Technical Bulletin

Bulletin Number: 417 Revision Number: R-02

P.O.S. WINDOW SECURITY CHANNEL

All Coca-Cola Landscape Venders

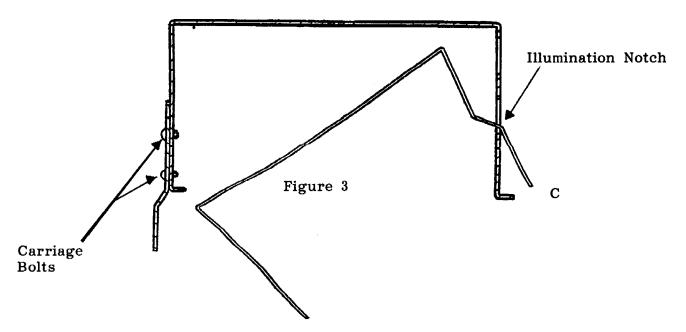
- 4. Remove the two vandal panel carriage bolts which are to the left of the P.O.S. Window (See figure 3, page 2).
- 5. Look at the P.O.S. Window. If the P.O.S. Window does not extend down to below the bottom studs, use the nylon spacers to fill the gap before installing the security channel.

NOTE: If Dollar Bill validator is to be installed the validator mounting frame must be in place at this time.
- 6. Install the P.O.S. Window Security Channel by inserting the offset leg "C" through the rearmost illumination notch. (See figure 3, page 2.)

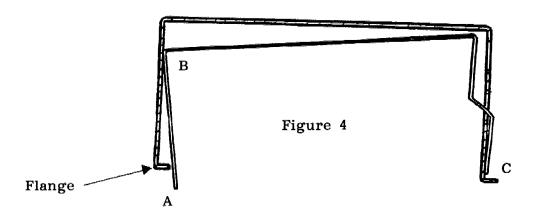
7. Push channel into place by applying pressure to area "B" of the P.O.S. Window Security Channel, (See figure 4, page 2) until leg "A" (See figure 4, page 2) snaps behind the flange.
